GOVERNMENT OF INDIA  
MINISTRY OF ENVIRONMENT & FORESTS  
**Central Zoo Authority**

F. No. 19-256/93-CZA(193)(Vol. III)(M)/2050

**Sub:- Construction of enclosures at Nagaland Zoological Park, Rangapahar.**

**Ref:- Your office letter No. FOR/WORKS-1/2001(Pt) dated 14.10.2011.**

GREAT INDIAN HORNBILL ENCLOSURE

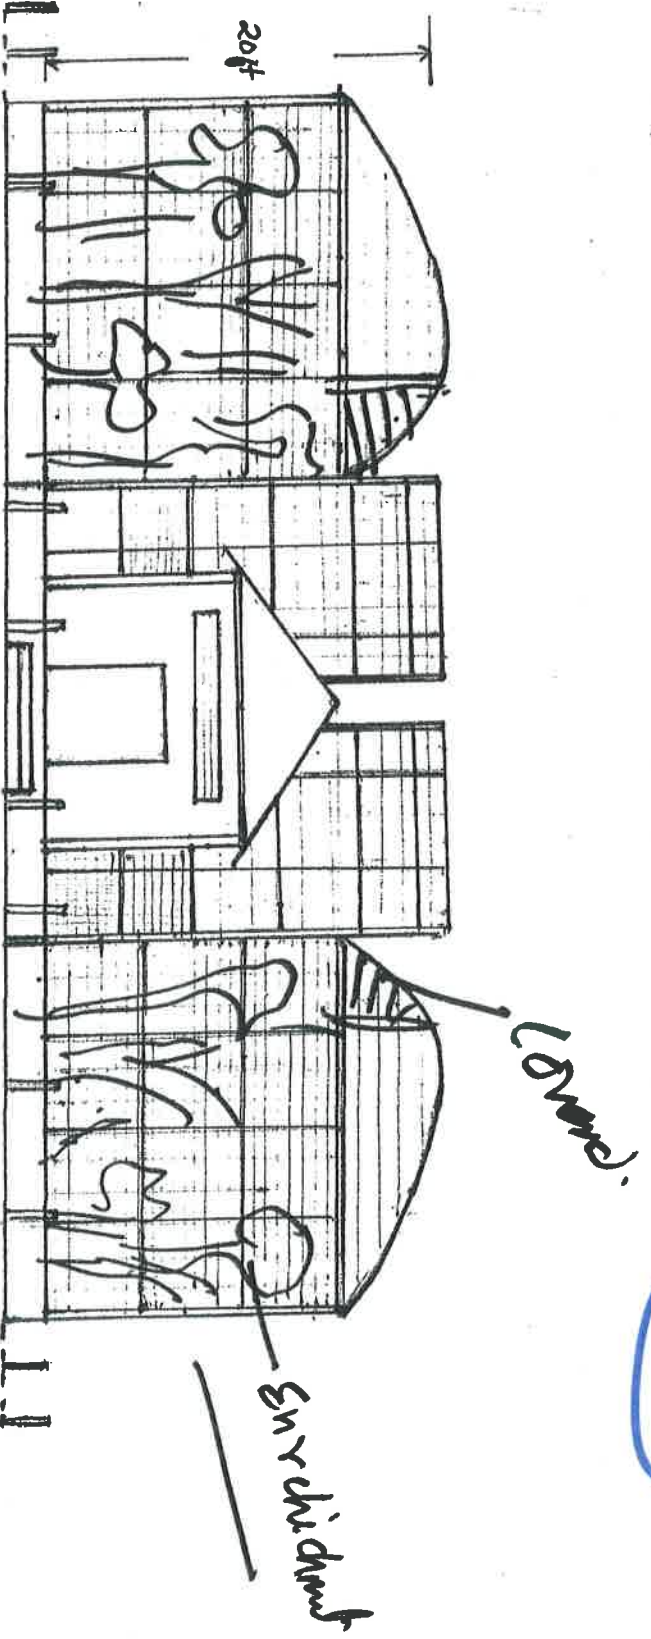
- One third portion of the roof should be covered to protect the birds during the monsoon.
- The areas for roosting and nesting of birds should be provided in such a way that the birds are protected from rain. An appropriate perches using natural material available locally should be provided along with the live plants and trees inside the enclosure as an environmental enrichment.

Keeping in view of the above, revised design should be submitted to the Central Zoo Authority for records. A copy of the design indicating the necessary amendments to made are enclosed herewith for your perusal.
